Site Plan and Design Review Staff Report and Recommendation

LAND USE REQUEST: Site Plan and Design Review of a proposed 9,100-square-foot Dollar General retail store and parking

FILE NUMBER: 311-19-000006-PLNG

PROPERTY LOCATION: 1121 Gales Creek Road

Site Plan

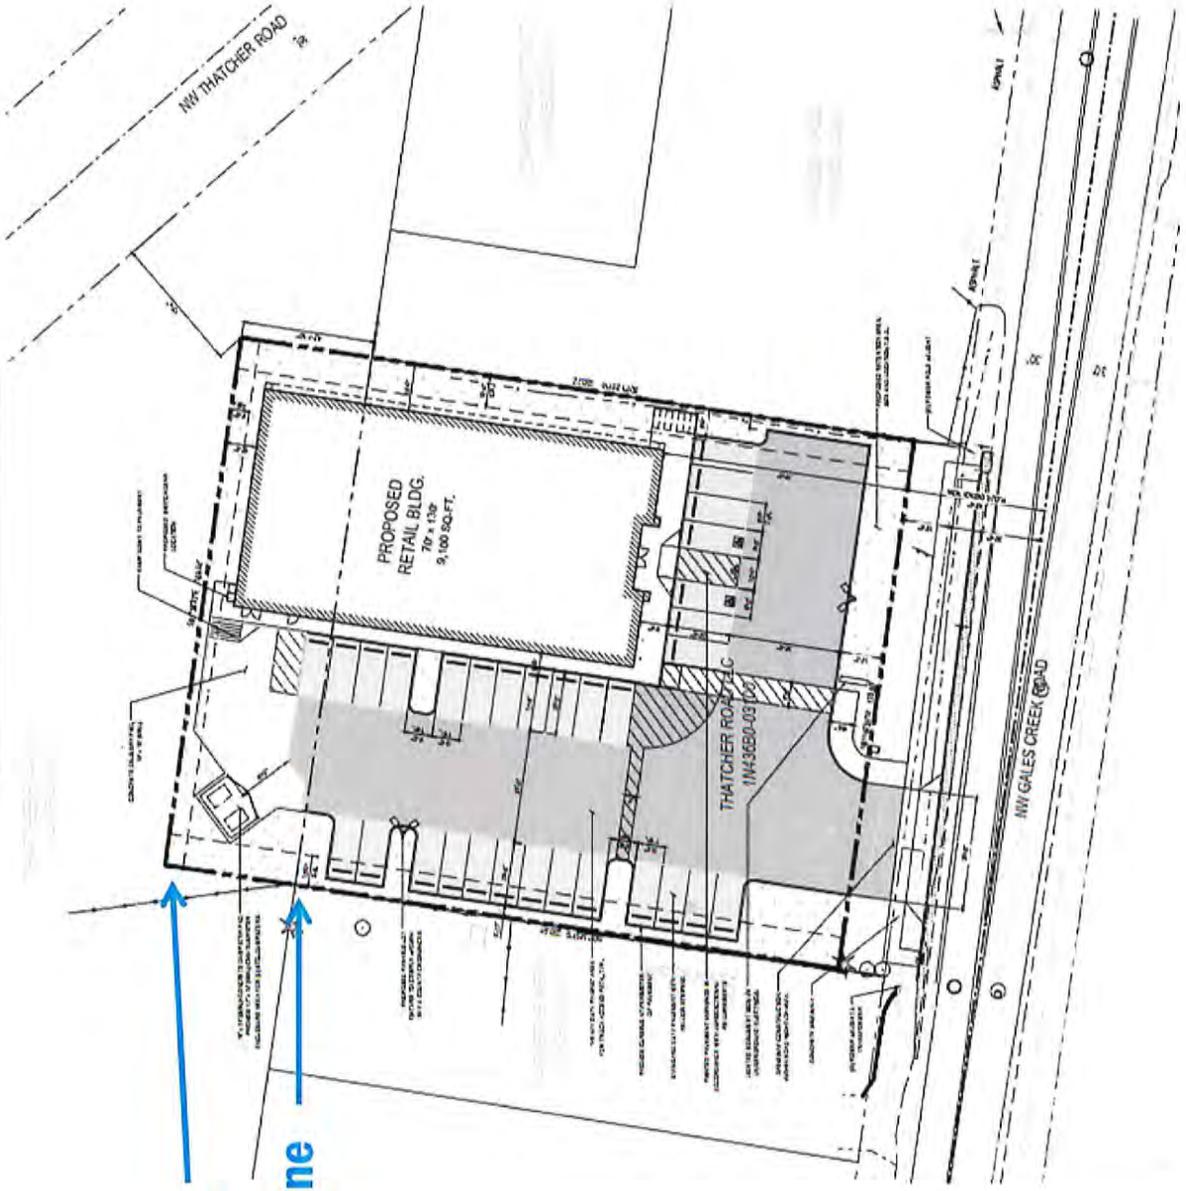
DC §17.4.315(K) stipulates that “No parking or vehicular circulation areas shall be located between the building and the street.” As noted above, this is a single-building project, and not part of a planned development. Parking can be located between the building and the street through application of the Design Guidelines if found to result in a higher quality development than would result under a strict interpretation of the code.

Staff has included a **condition** to install a landscape island at the building's southwest corner where the two pedestrian walkways converge, in order to provide more separation between pedestrian and vehicular traffic and increase the amount of landscaping. With that condition, the landscape plan appears to comply with the provisions of this code section.

Minimize building setbacks from any public street right-of-way. Zero lot line buildings along the public street right-of-way are encouraged to maintain an inviting and continuous storefront presentation. The building would be setback about 80 feet from the Gales Creek Road right-of-way. This width is necessary in order to provide maneuvering space for delivery trucks, and for the water quality facility which must be located at the lowest point of the property.

Use the area between the right-of-way and building to create a plaza court, planter area, bicycle parking or another amenity. The area forward of the building would be used for a water quality facility, bicycle parking, and vehicular parking.

Front (South) Elevation

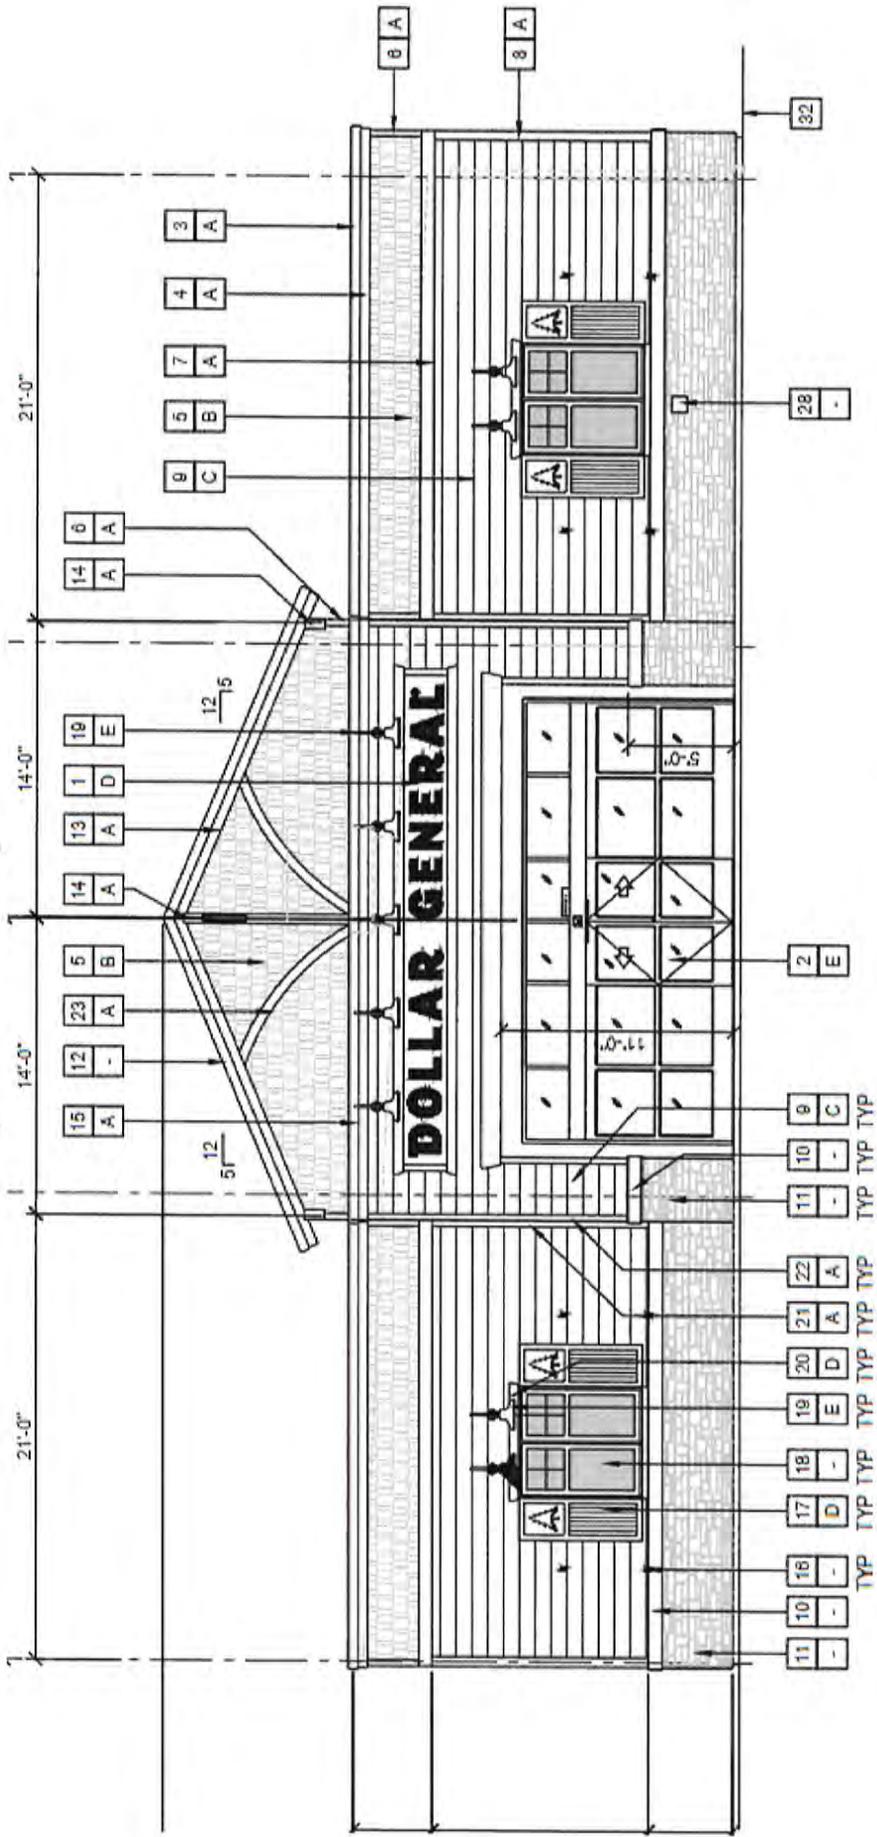
Canvas fixed or retractable awnings or horizontal metal canopies. No awnings are proposed. Awnings over the south-facing windows could provide an additional architectural detail while also providing some weather protection and minimizing solar gain.

Visible frame or trim detail surrounding the entry. No specific frame or trim detail surrounding the entry is proposed.

1. Reducing the length of the front car park stalls and front walkway width so that the building would be located closer to the street.
2. Awnings over the windows and faux windows for additional architectural detail, or a continuous awning over the south and west walkways to provide weather protection.
3. Additional windows in the south elevation, facing the street.
